**C0033 – NETWORK RAIL EV CHARGING POINT  
INSTALLATION PROJECT  
DECARBONISATION PROGRAMME  
MANCHESTER PICCADILLY SHORT STAY CAR PARK  
E&P FORM A**

**C0033-POI-FOA-EP-140001**

**Revision: A02**

**Date: 1<sup>st</sup> July 2022**

**Figure 4: Proposed Feeder Pillar**

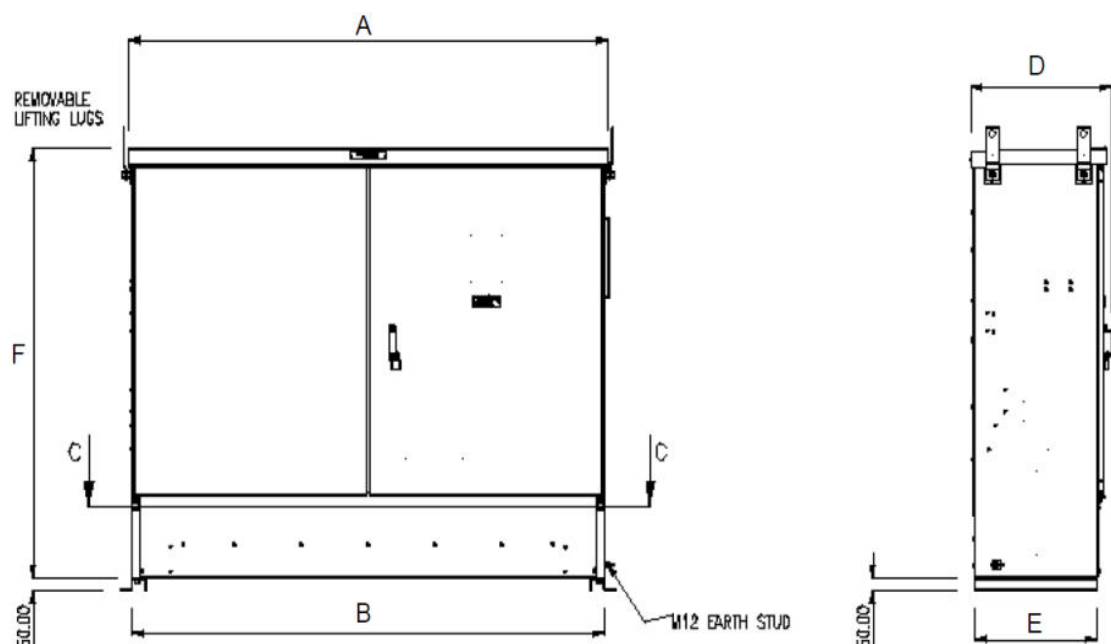
| Network Rail (NR) |                                                                                                                                                                                                       |    |      |                                    | Supplier                       |                                                                                                                                                                                                                                                                                                                                                                                                |    | NR                              | * |
|-------------------|-------------------------------------------------------------------------------------------------------------------------------------------------------------------------------------------------------|----|------|------------------------------------|--------------------------------|------------------------------------------------------------------------------------------------------------------------------------------------------------------------------------------------------------------------------------------------------------------------------------------------------------------------------------------------------------------------------------------------|----|---------------------------------|---|
| 02                | Point 7.2.2 (page19), the proposed feeder pillar should have a sloping roof to prevent littering                                                                                                      | JW | 2A   |                                    |                                | Please note that the reference doc (Ref: 172768-KCL-FOA-EDS-000028.2) is incorrect as this is the Signed A1 for Manchester.<br><br>The designer assumes this comment refers to Form A document (Ref: 172768-KCL-FOA-EDS-000036), and confirms this note will be updated in the Form A.                                                                                                         |    | Yes                             |   |
